DATE: September 16, 2020
TO: Board of Architectural Review Chair and Members
THROUGH: Jason Sutphin, Community Development Division Chief *JDS*
FROM: Tommy Scibilia, BAR Liaison *TS*
SUBJECT: **Breezeway Motel and Fairfax Gardens Properties – Work Session**

1. Case Number:	No active case
2. Address:	10829 Fairfax Boulevard, 10807-10818 Cedar Avenue, 3937 Walnut Street, and 3930, 3932, and 3934 Oak Street
3. Tax Map Parcels:	57-1-14-043, 57-1-14-055A, 57-1-14-083, 57-1-14-077A, 57-1-14-076A, 57-1-14-075A
4. Request:	31 townhouses, 34 two-over-two stacked condominiums, 5-story multifamily building, site improvements
5. Potential Applicant:	Pulte Homes, LLC
6. Applicant's Representative:	Robert D. Brant
7. Status of Representative:	Agent
8. Current Zoning:	CR Commercial Retail, RMF Residential Multifamily, RH Residential High, Architectural Control Overlay District
9. Proposed Zoning:	PD-R Planned Development Residential, Architectural Control Overlay District

Proposed Redevelopment of the Breezeway Motel & Fairfax Gardens Apartments

City of Fairfax Board of Architectural Review Work Session

BUILDING 1 - FRONT ELEVATION
 Scale: 1/8" = 1'-0"

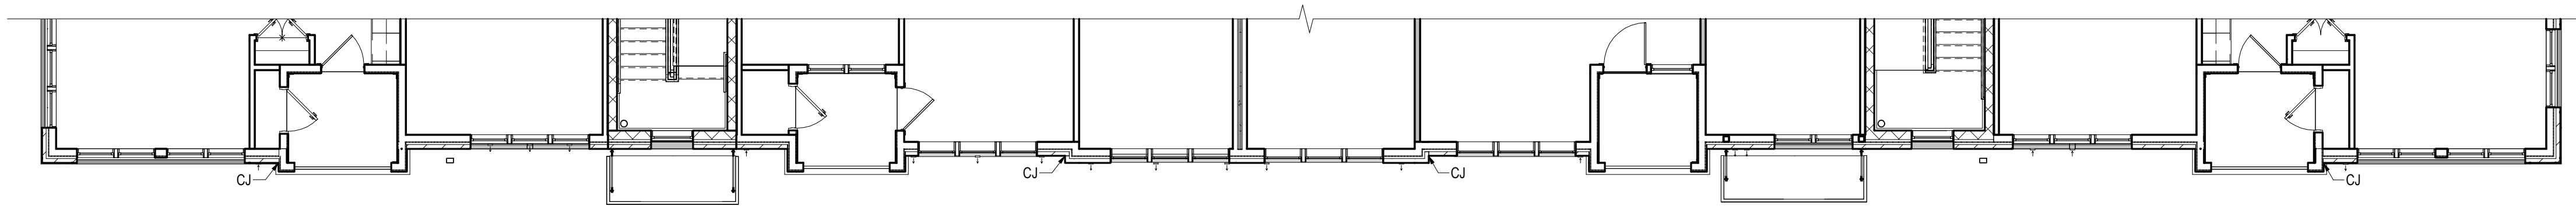
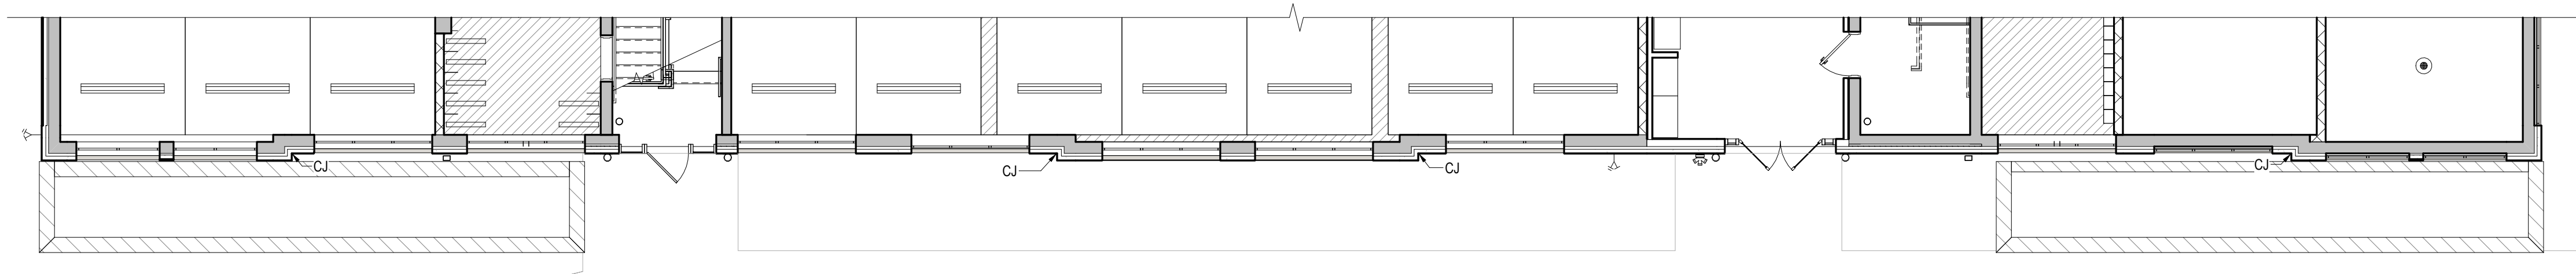
Add pedestrian interest and human scale to the north elevation of the ground floor/podium parking structure. Ideas could include using material or color variation, adding decorative elements and human-scale lighting, and enhancing the base of the building with additional foundation plantings.

This comment was partially addressed. Raised brick planter beds and foundation plantings were added on all sides of the multifamily building. Staff encourages the BAR to make further recommendations for how this part of the multifamily building can be further enhanced with pedestrian-scale design features.
